From: Nicola Spencer
Sent: 08 May 2019 16:46
To: Lynnyrd Wolfe
Subject: FW: AW/82/19/HH - 17 Downing Close
Attachments: 17, Downing Close 45 degree Amendment Plan pdf.pdf

PROPOSED SINGLE STOREY EXTENSION AT 1'
FOR MR. & MRS. S. PAGE.

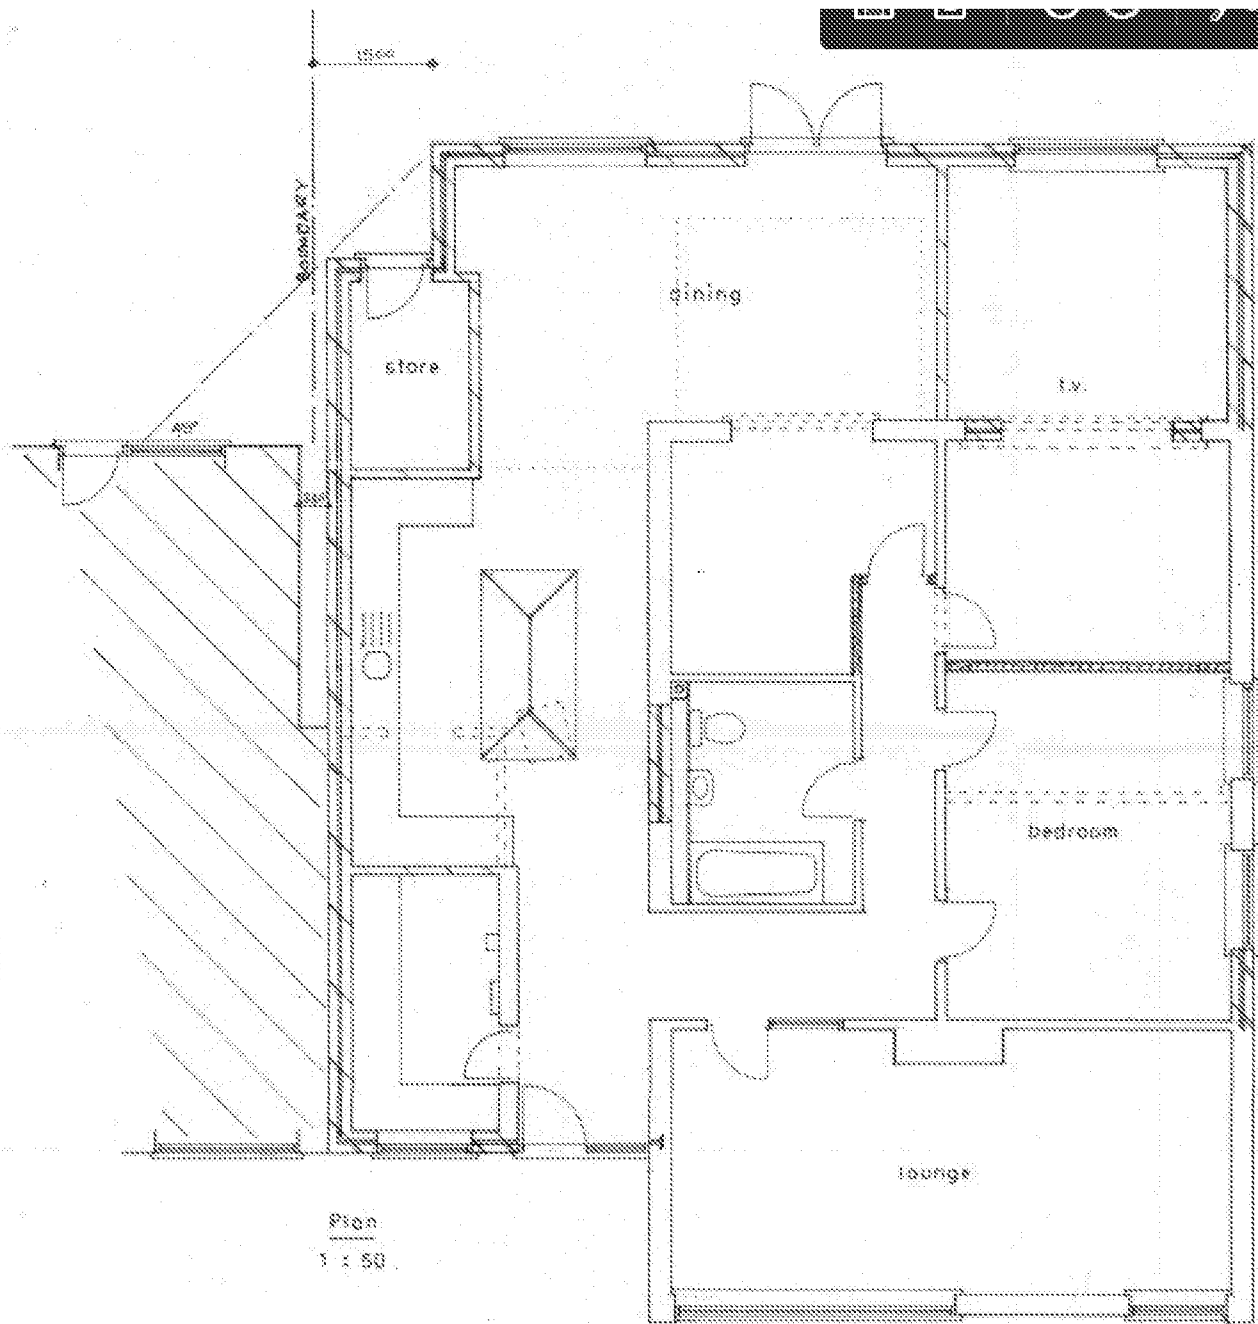
It has been brought to our attention that the detail of the rear of no. 15 Downing Close is not drawn correctly, and so the implied 45 degree rule, as indicated by your 45 degree line appears, would not be applied correctly.

I would appreciate it if you could reply of acknowledgment. And I attach the illustration which the neighbour questions.

Attached as promised.
